Data provision of the new PALSAR-2 standard products with bug fixing of Spotlight mode and ScanSAR mode (burst processing) for Interferometric SAR anomalies

April 21th, 2021

Japan Aerospace Exploration Agency

Azimuth frequency before

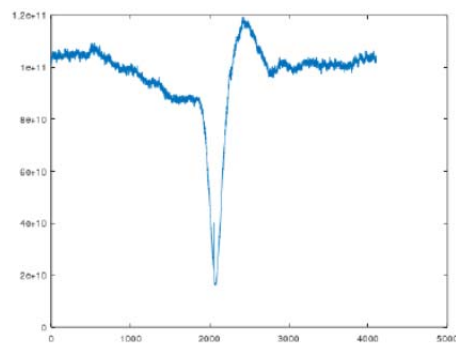
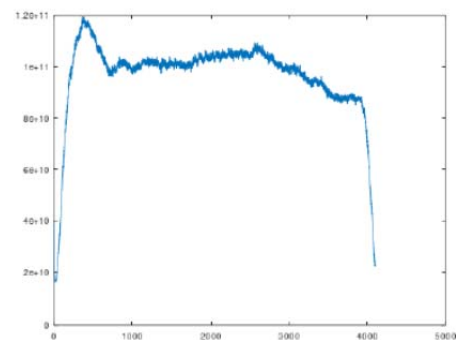
- It was found that Interferometric SAR analysis (InSAR) using the standard product L1.1 of PALSAR-2 Spotlight mode and ScanSAR mode (burst processing) may cause unexplained fringes in the azimuth direction.
- As a result of checking the product processing software, there is an error that the frequency band in azimuth direction is shifted by half of the bandwidth in these modes, and it causes the above-mentioned InSAR error.

- The error in the standard product processing has been fixed in March, 2021. Only the L1.1 product for Spotlight and ScanSAR modes (burst processing) is changed. Stripmap and ScanSAR (full aperture processing) modes and the product levels other than L1.1 are not changed.
- Please note that InSAR processing between products that have been processed before and after the correction will not give the correct results. For products that

have been processed before correction, it is possible to convert them to the same state as after correction by doing the following process. On the other hand, if you want to convert inversely, you should do the same process as below.

Alternately multiply 1, -1, 1, -1, ... for each azimuth line.

(Equivalent to a 1/2 shift in bandwidth)
